Commission of Architectural Review

6. COA-166438-2025	Final Review	Meeting Date: 5/27/2025
Applicant/Petitioner	Will Gillette	
Project Description	Construct a two-story single-family detached dwelling on the vacant parcel.	
Project Location		
Address: 2206 Jefferson Ave, Richmond, VA 23223		
Historic District: Union Hill		
<p>High-Level Details:</p> <p>The project proposes the construction of a new two-story single-family detached dwelling on a currently vacant lot.</p> <p>The surrounding context is primarily residential, with contributing Late Victorian and Italianate-style buildings that typically feature two-story heights, three-sided chamfered projecting bays, and narrow front porches. The applicant proposes a modern interpretation of these traditional forms, including a rectangular projecting front bay, lap siding, and a four-bay façade. Following conceptual review in April 2025, the applicant made revisions including extending the front bay to the roofline and revising the bay window composition.</p>

Figure 3: Surrounding Context

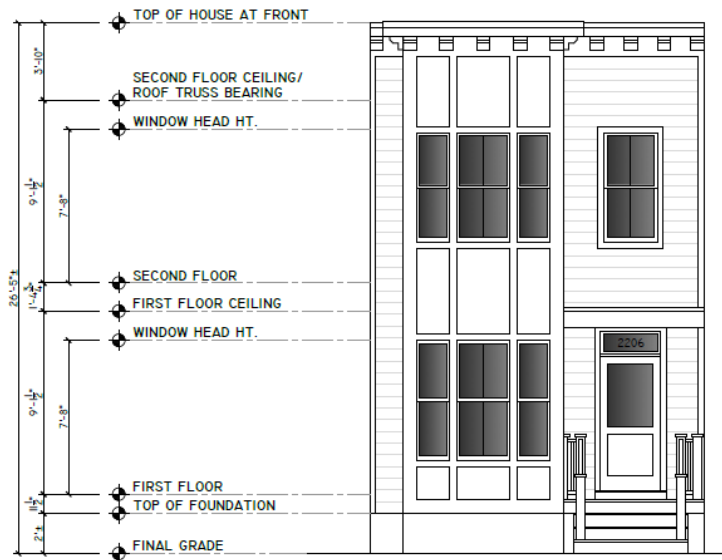
<i>specific combination of massing, size, symmetry, proportions, projections and roof shapes that lend identity to a building. Form is greatly influenced by the architectural style of a given structure.</i>	<p>The contextual image (Figure 3: Surrounding Context) demonstrates the intent to align the new construction's final grade, porch height, window placement and roofline with the existing streetscape. The drawing shows the neighboring structures at 25'-10" high, with the proposed construction sitting at a height of 26'-5".</p> <p><u>Staff recommends ensuring that the developed design continues to abide by these set parameters, and that the total height of the new construction does not exceed what is currently proposed.</u></p>
Standards For New Construction: Form, p. 46	<i>2. New residential construction should maintain the existing human scale of nearby historic, residential construction in the district.</i>	<p>The proposed porch features a flat roof covering, which differs from the more common hipped porch roofs found in the district, but appears compatible with the proposed contemporary design.</p> <p>As the front and side elevations do not yet clearly depict the form of the porch roof; <u>staff recommends providing additional elevation views and section details to fully illustrate the porch roof design.</u></p>
